**TOWN OF MOUNTAIN VILLAGE
DESIGN REVIEW BOARD REGULAR MEETING
THURSDAY SEPTEMBER 3, 2015, 10:00 AM
2nd FLOOR CONFERENCE ROOM, MOUNTAIN VILLAGE TOWN HALL
455 MOUNTAIN VILLAGE BLVD, MOUNTAIN VILLAGE, COLORADO
AGENDA**

TO: Design Review Board
FROM: Savannah Jameson, Planner II
FOR: DRB Public Hearing on September 3, 2015
DATE: August 25, 2015
RE: Consideration of a Minor Revision Application on Lot 38-50-51R

Legal Description: Lot 38-50-51R, Mountain Village Filing No. 1
Address: 568 Mountain Village Blvd.
Applicant/Agent: Dylan Henderson
Owner: Madeline Property Owner, LLC, dba Northview Hotel Group
Zoning: Village Center Zone District
Existing Use: Mixed Use Development
Proposed Use: No change in use
Adjacent Land Uses:

6 Portechachere - Reflected Ceiling Plan
3/16" = 1'-0"

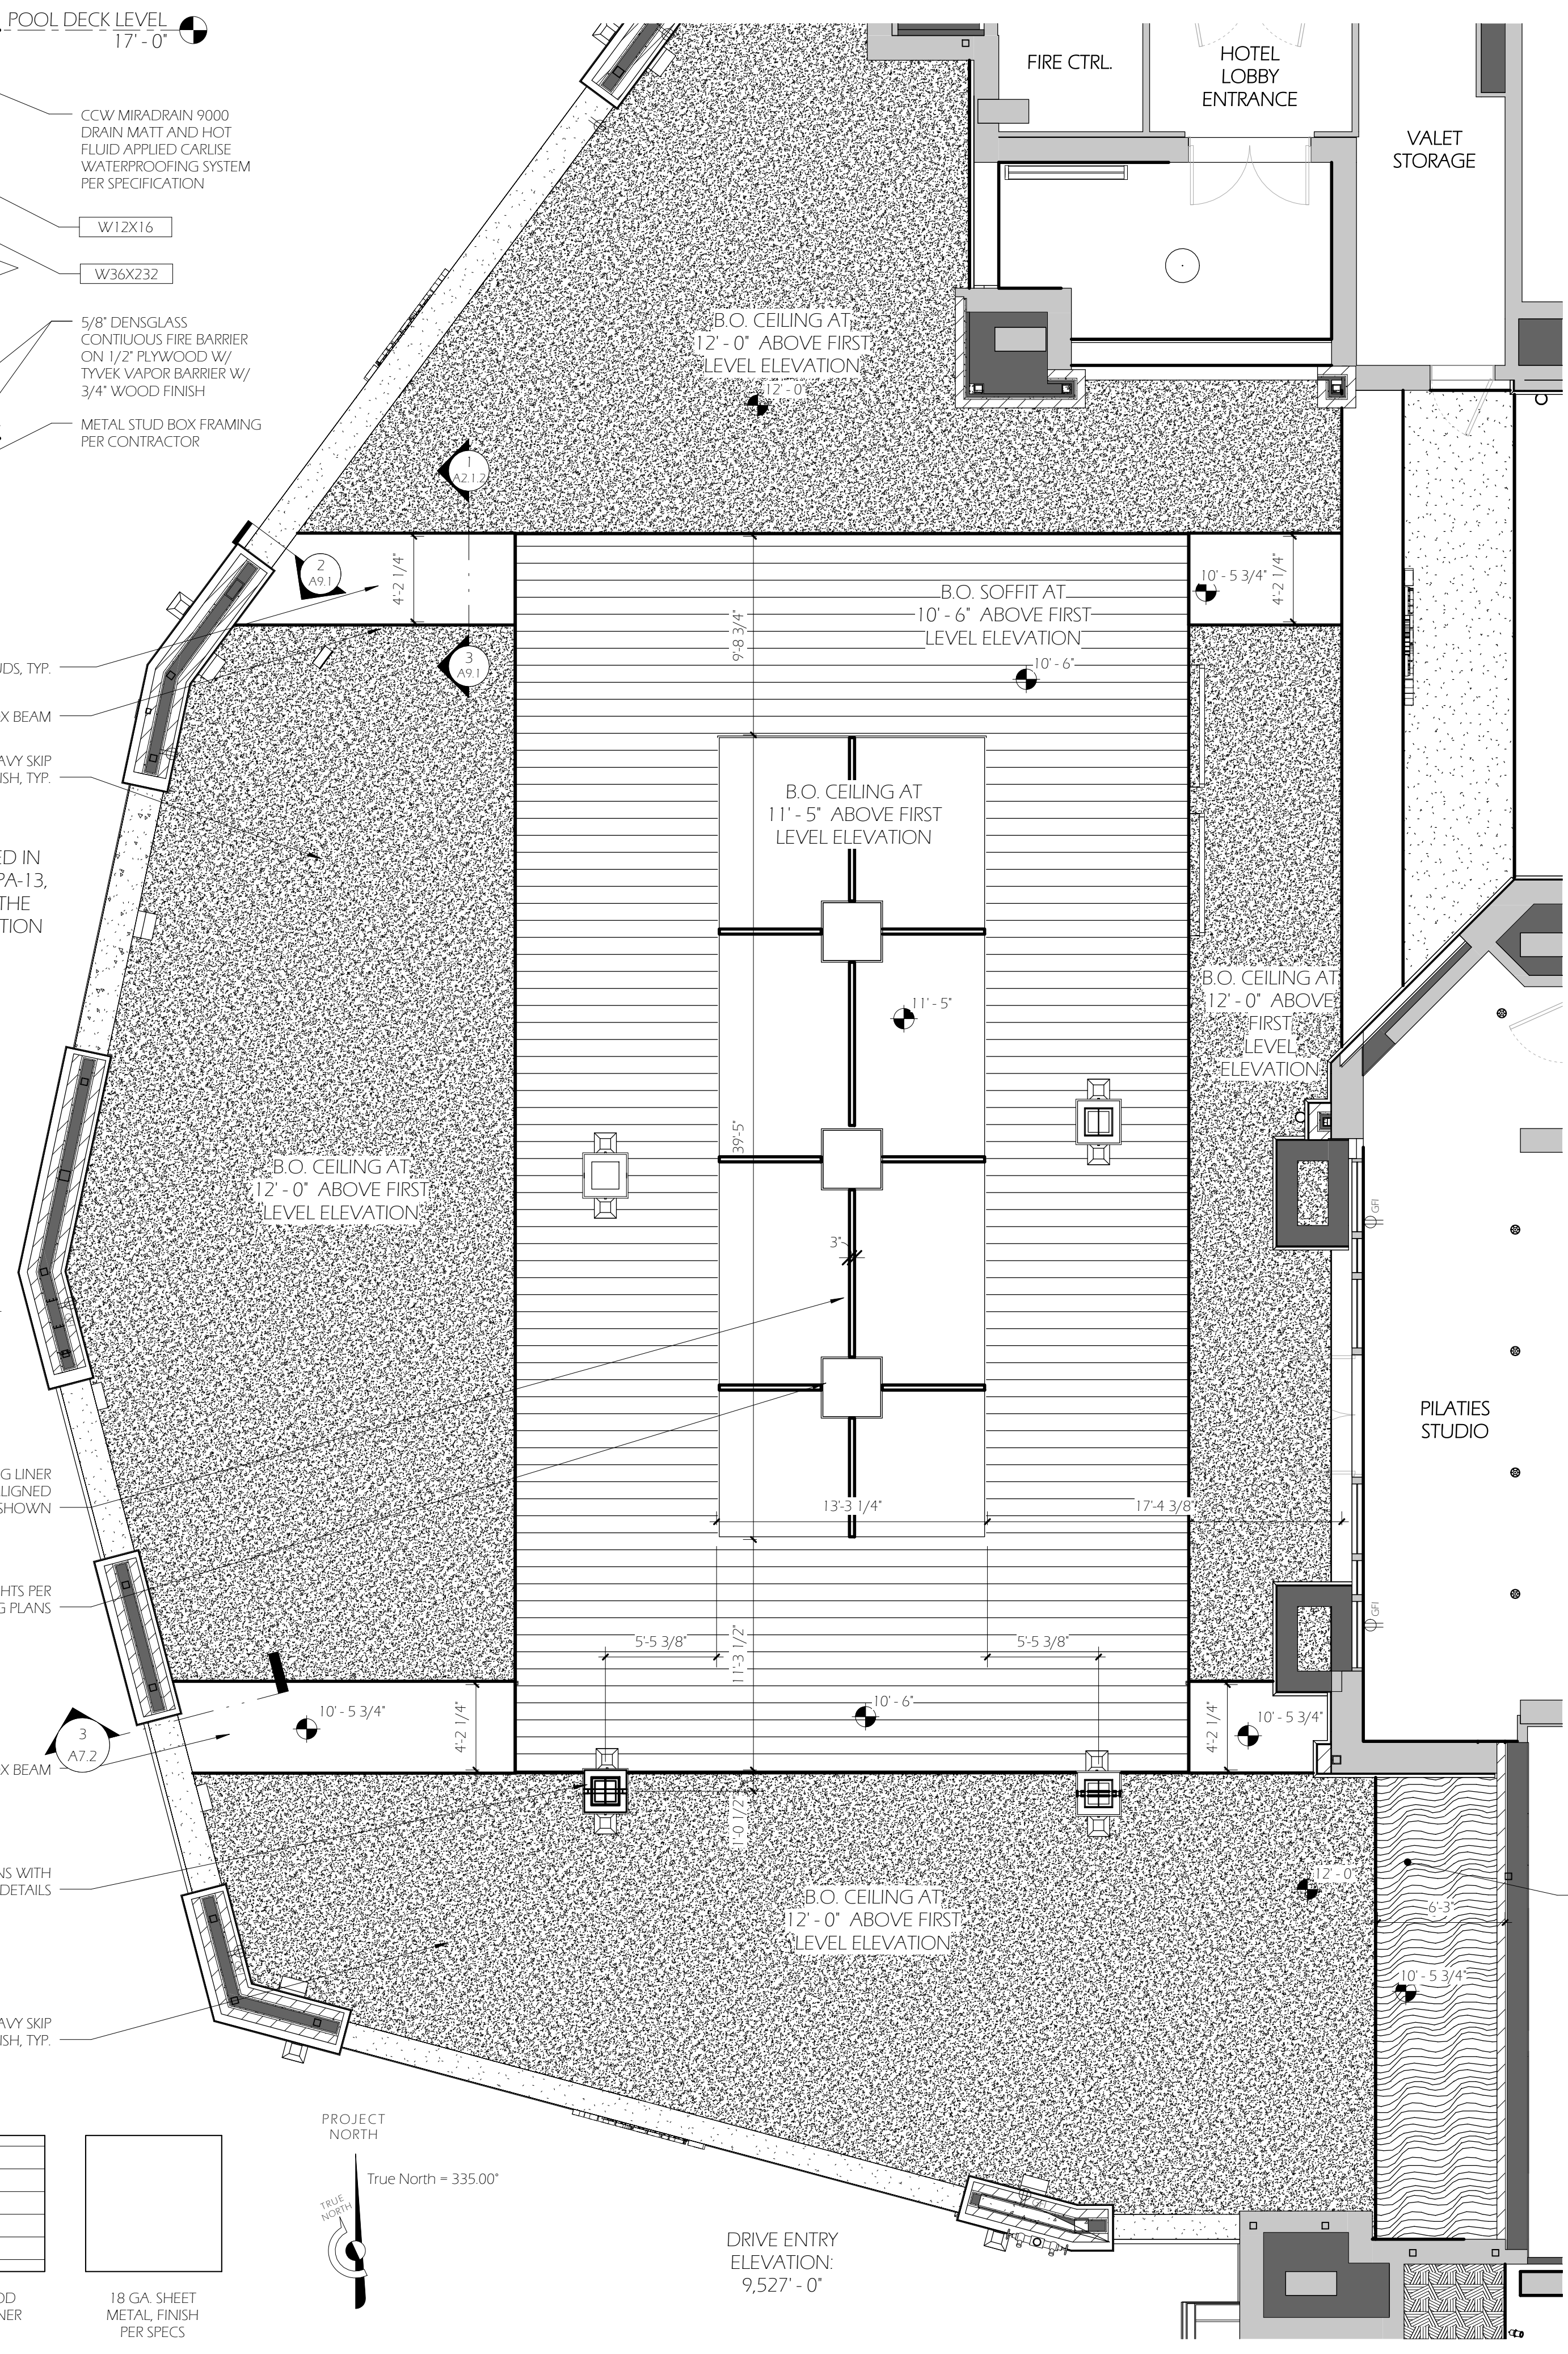
2. The proposed revised ceiling plan for the porte cochere will simpler in design. The important consideration of this ceiling plan is that it incorporates lights that do not bleed from the interior of the space to the exterior.
3. The first floor of the existing southwest façade will be pushed out to be flush with the columns to allow for an expansion of the ski valet.
4. Proposed revision to the lighting plan. All exterior lights will be dark sky compliant and meet the CDC Lighting Regulations 17.5.12.

① Elevation - Portecachere NW
 1/4" = 1'-0"

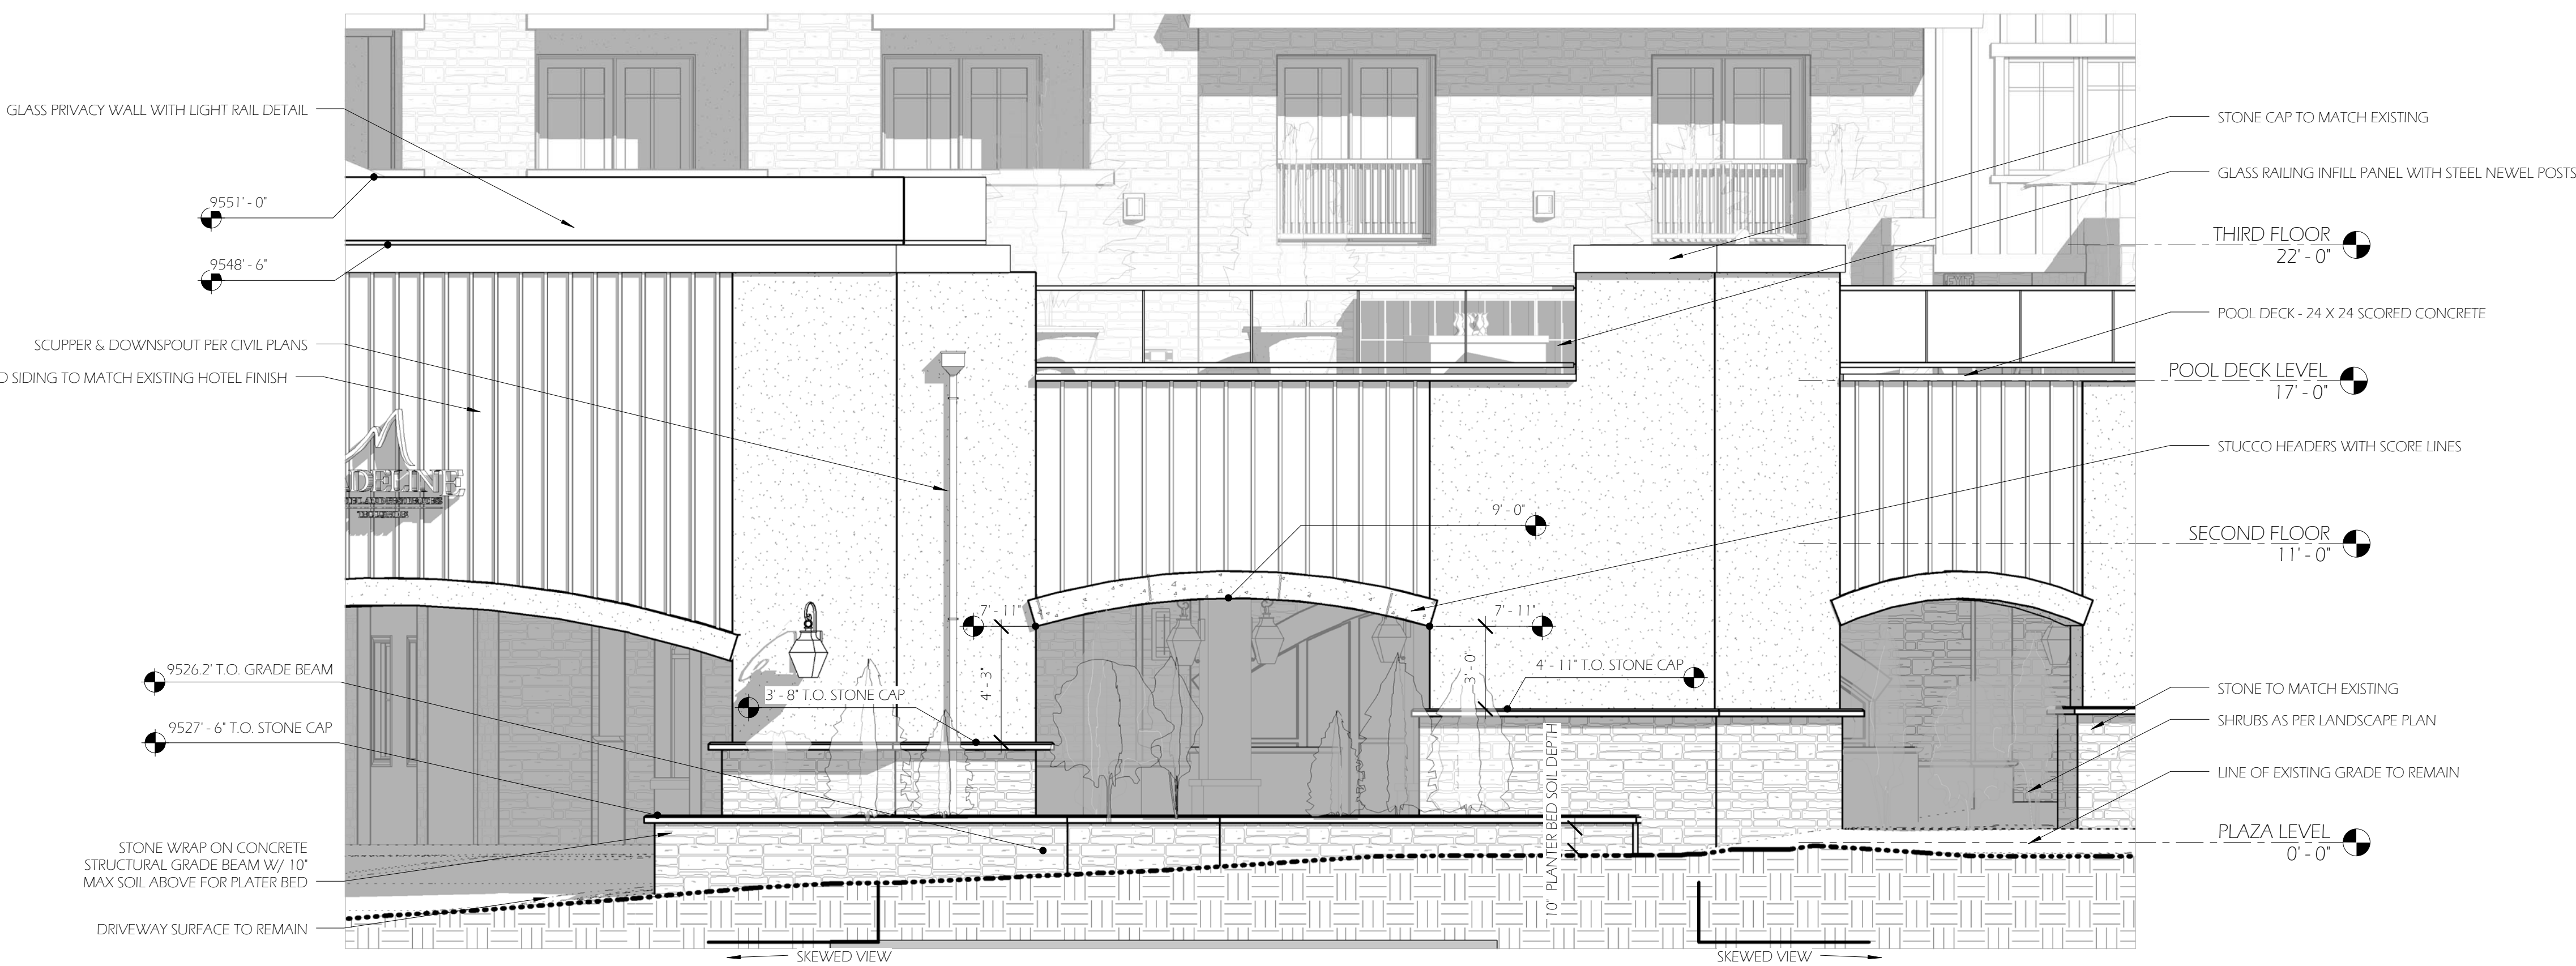
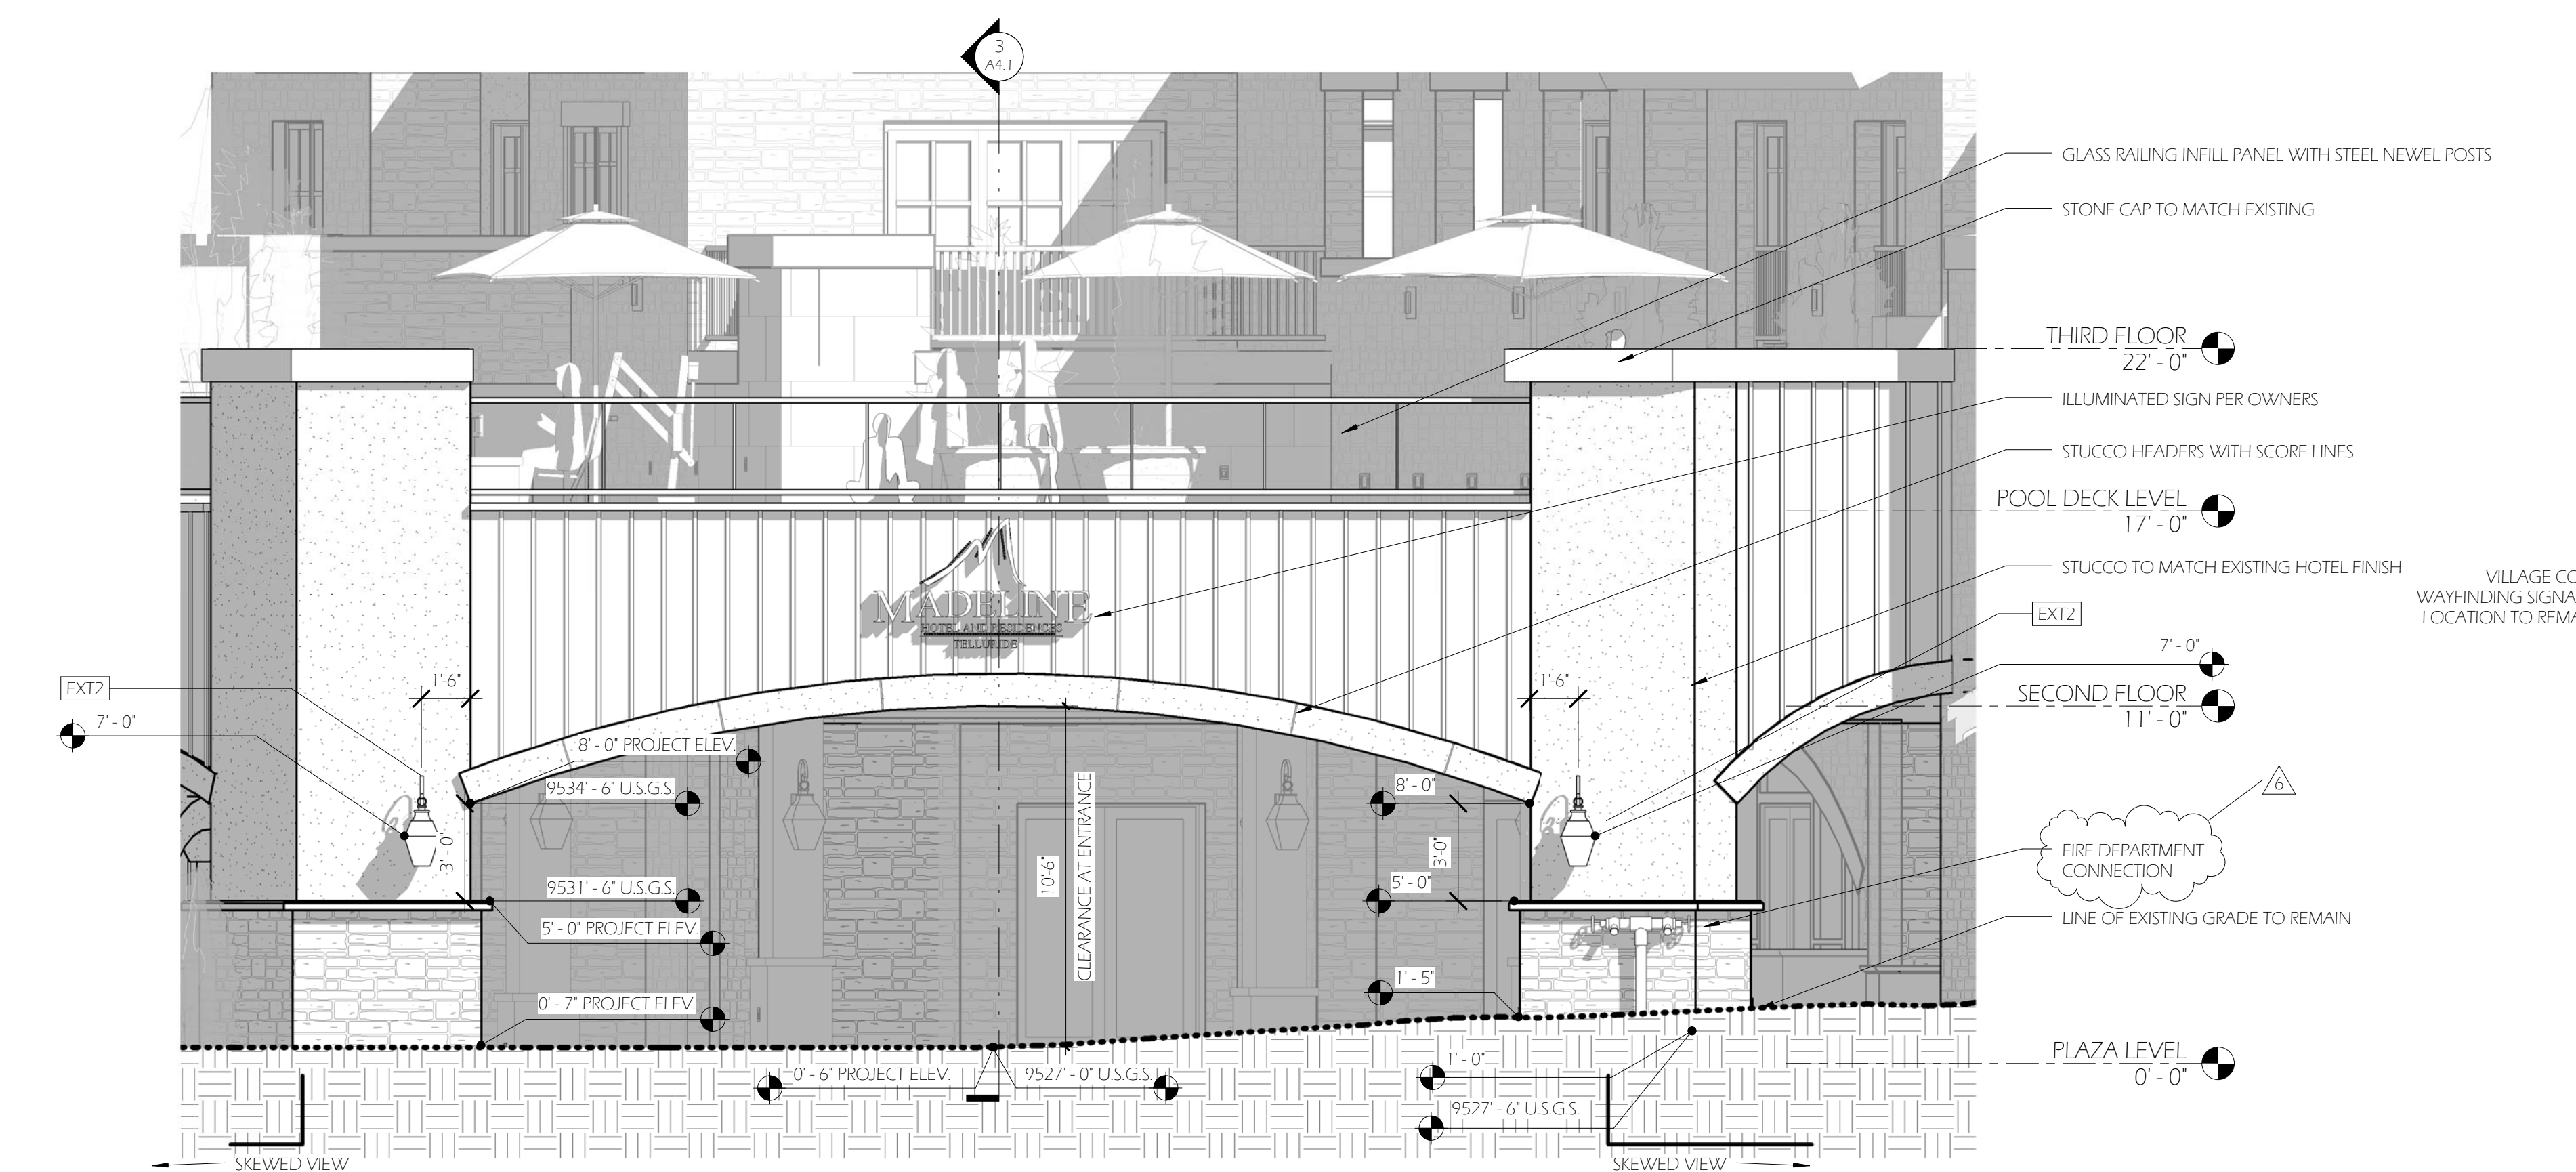
1. Change in porte cochere materials. The porte cochere as approved had a full stone exterior. The revision is for a stucco finish with a stone base. The proposed materials

are compatible with the existing materials. The stone base meets CDC guideline 17.5.6 calling for a solid, heavy grounded base. Per the CDC for commercial development, the first floor, primary material shall be stone or stucco. The proposed material change is in keeping with this criteria.
